**SERVICE INFORMATION**

Bulletin Nbr: 811-2100

**Noise from the door window glide rollers**

All Saab 9-3 Convertible M98 - M99 up to and incl. chassis no. X7057279.

D843B003

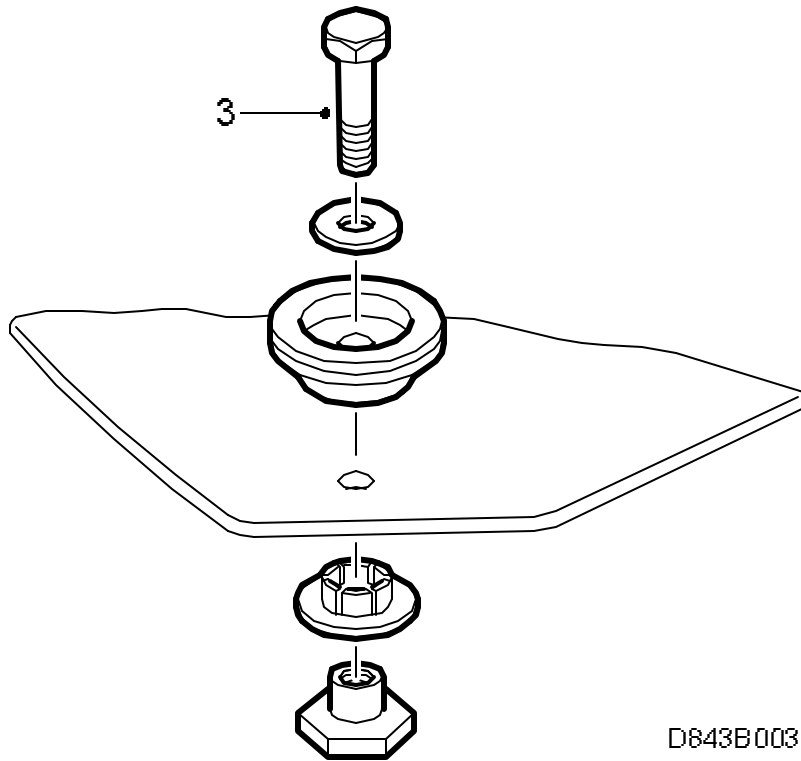
On certain cars, the friction in the glide rollers can cause high-frequency creaking noise. In case of customer complaints, change the glide rollers to new rollers with the following part number.

2. Lay the window glass on a soft and level surface.
3. Remove the glide rollers. Loosen the screw (hold the nut on the rear of the window). Remove the glide roller.
4. Fit the new glide rollers part no. 51 13 436. Tighten the screws.

51 13 436 Glide roller dark grey (4 pcs/car)

**Tightening torque : 9 Nm (6.7 lbf ft)**
